Adamstown Boulevard - Phase I

RFI Response - SDZ22A/0007  
September 2022

## RFI Item 3.b

T1	FOR TENDER	10.08.2022
<b>REVISIONS</b>		
Job No.	2302A	Drawn By KFR
Dwg No.	L1-102	Checked By JM
Scale	1:750 @ A1	Date AUG 2022
<b>JOB DESCRIPTION</b>		
Site	ADAMSTOWN BOULEVARD	
Project	ADAMSTOWN BOULEVARD PHASE 1	
Title	TEMPORARY BOUNDARY CONDITIONS

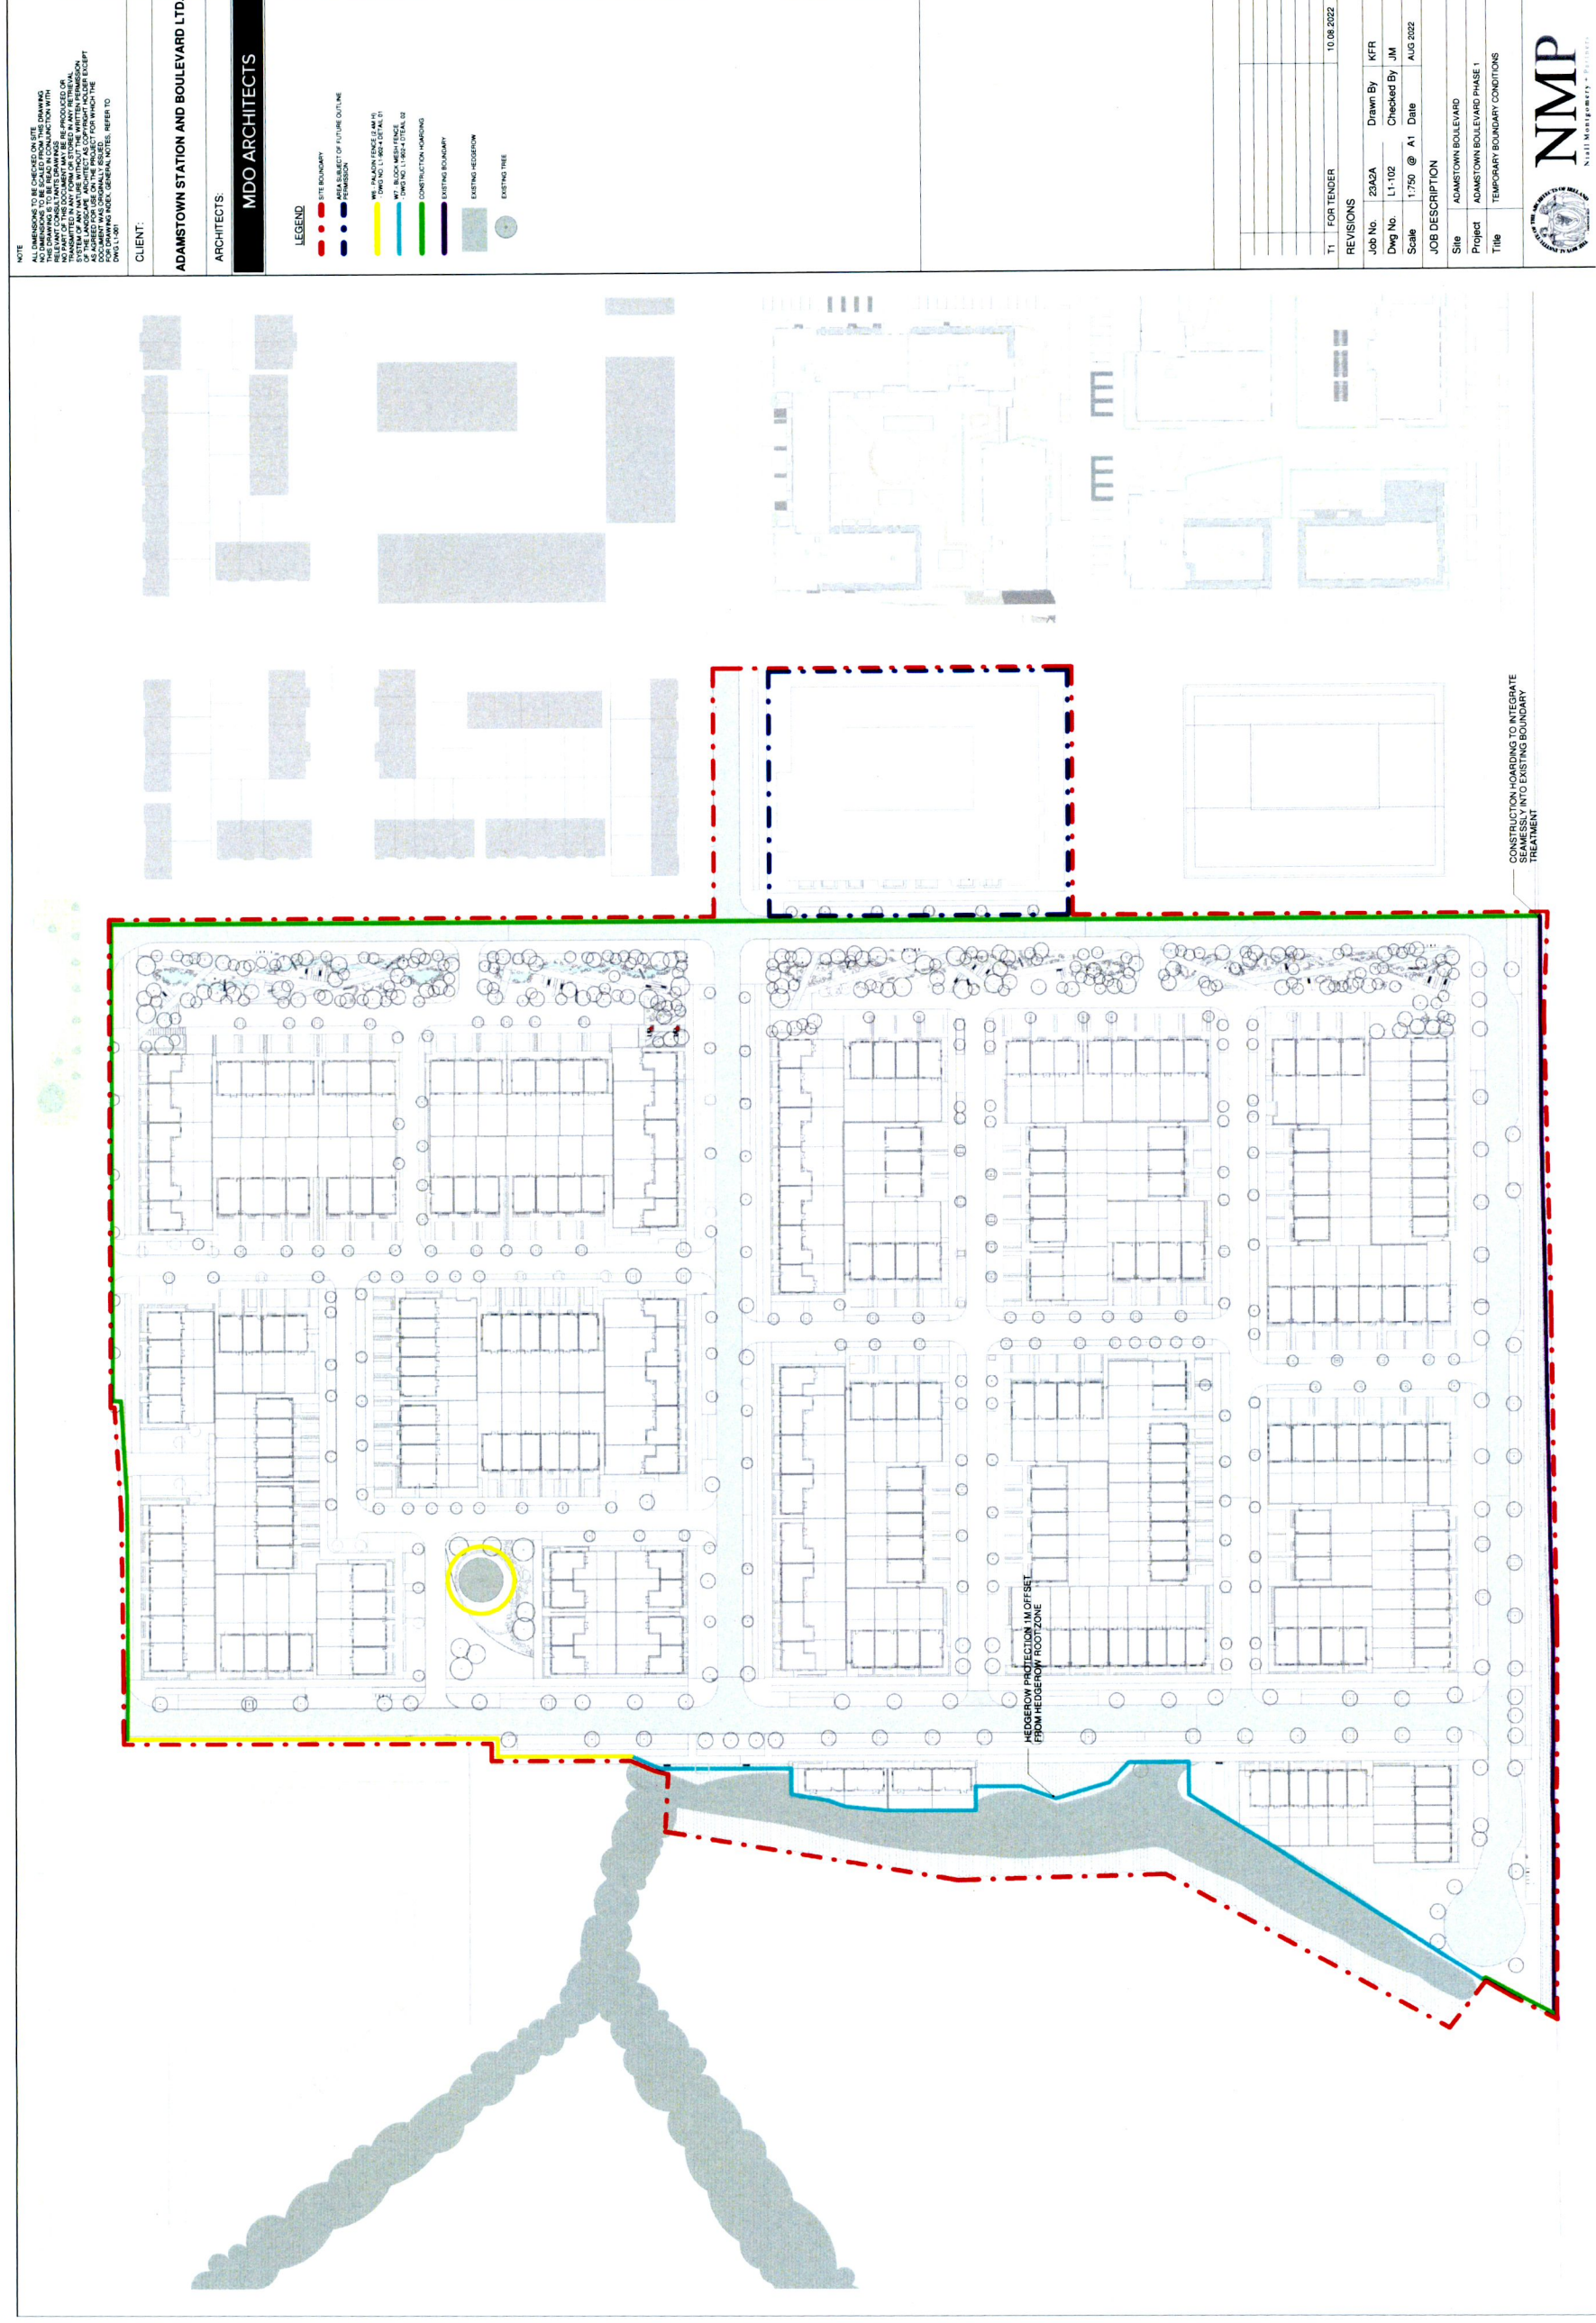
#### 3.b The applicant is requested to provide revised boundary treatment details / landscaping details for the boundary of the properties close to the hedgerow to the west

Refer to L1-102 – *Temporary Boundary Conditions* plan indicates that a block and mesh fence will align 1-2m from the edge of the root protection zone for the existing hedgerow to protect the biodiversity during the construction phase. The existing oak tree located at the pocket park will also be retained and protected with paladin fence. Refer to details L1-902-4
